## APPLICANT'S SUPPLEMENTAL APPLICATION NARRATIVE

APPLICATION: City Casefile #0701-21-1 DR

PROPOSAL: Design Review to construct a building that includes processing, storage, and retail sales of fish and shellfish.

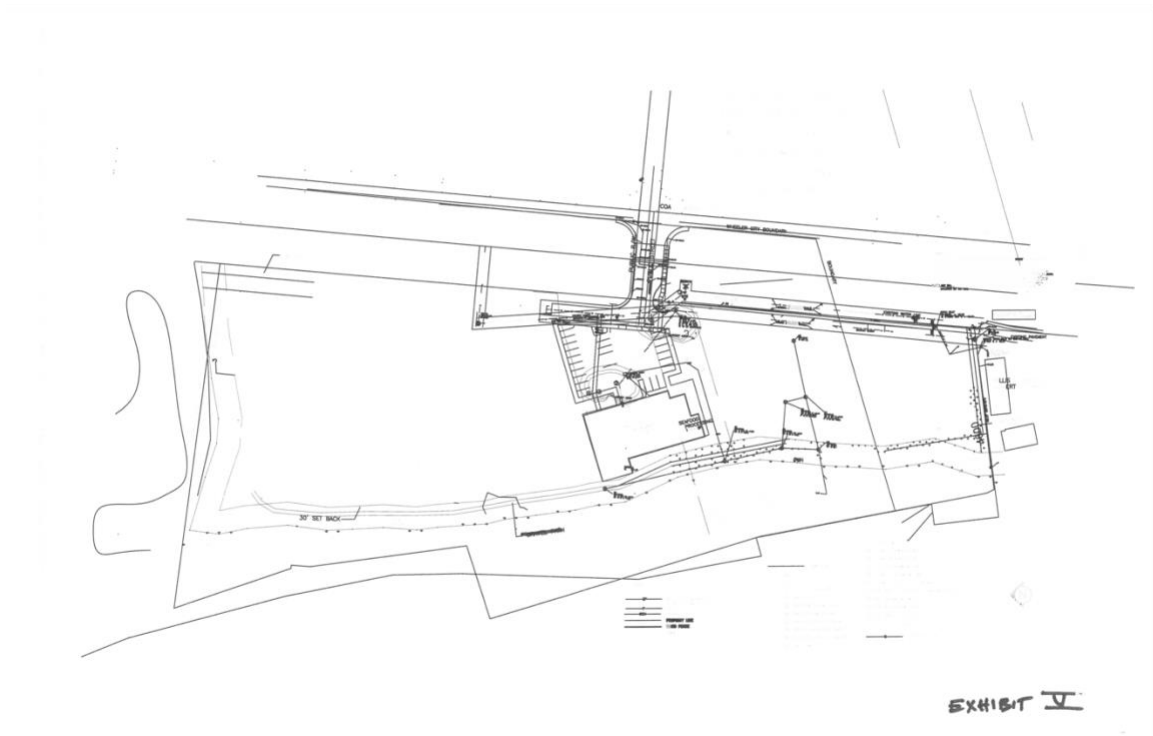
- The application did not demonstrate "how the height and scale of the proposed buildings will be compatible with the site or adjoining buildings."

Supplemental Response: The project design is compatible with the site's layout and topography. As shown in the site plans, the footprint of the building and landscaping follow the curved Marine Drive alignment to the east and the sinuosities of the Nehalem Bay shoreline to the west. The project design is compatible with the site in terms of height and scale. The building will not exceed the Zones' height limitation of 24 feet, and the building consolidates a commercial and an industrial use, thereby reducing the structure's footprint and impact on the natural shoreline. As shown on the site plans submitted with the original application, reproduced below, the building occupies only a small portion of the site's total acreage:
